**PROPOSED MINOR RELAXATION OF PLOT RATIO (PR) AND BUILDING HEIGHT (BH) RESTRICTIONS FOR PROPOSED HOTEL USE AT
107-109 WAI YIP STREET, KWUN TONG (KWUN TONG INLAND LOT NOS. 570, 571, 572 & 573)**

Planning Application No. A/K14/835

Response-to-Comment Table

Appendix 1 Table 3

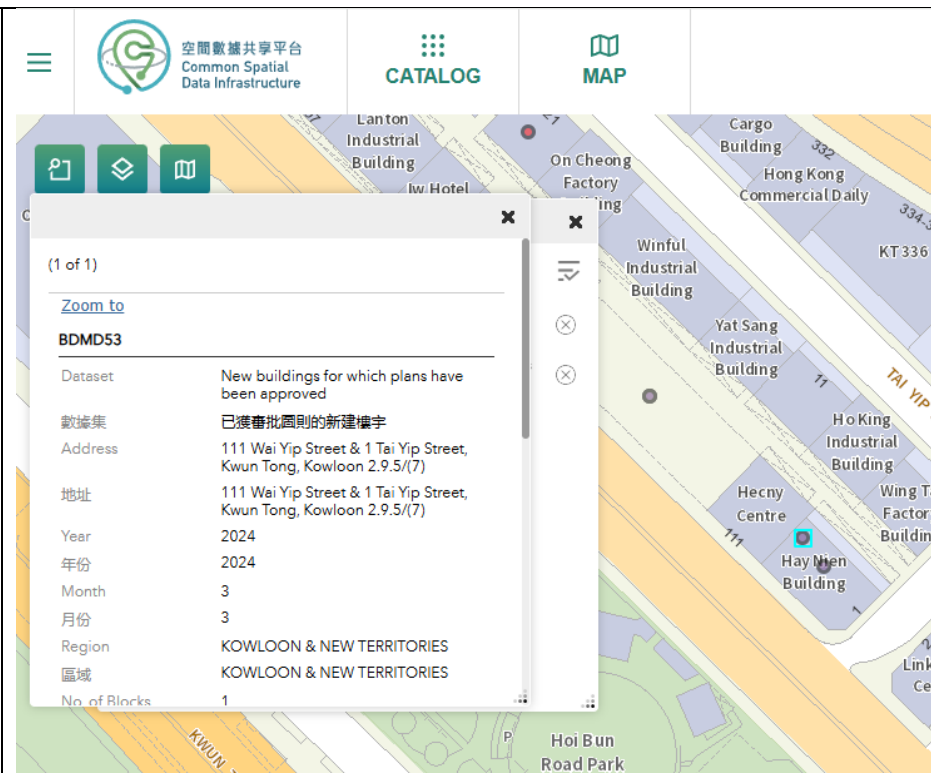
It appears that some of the sub-catchments are under planning stage, please provide supporting documents to show that the developments are on-going/completed to support the use of smaller estimated sewage flows comparing to the previous developments:

According to published information of BD, building plans have been approved for 111 Wai Yip Street and 1 Tai Yip Street after the planning approval, which proves that Catchment A – 7 is an on-going development.

For other planning approvals (i.e. Catchment A – 13, Catchment C – 20, 22 and 23), since no information showing their active status is found, the sewerage capacities are further tested in SIA taking into account the existing uses and parameters of these sites. Attached please find the replacement pages of the updated SIA.
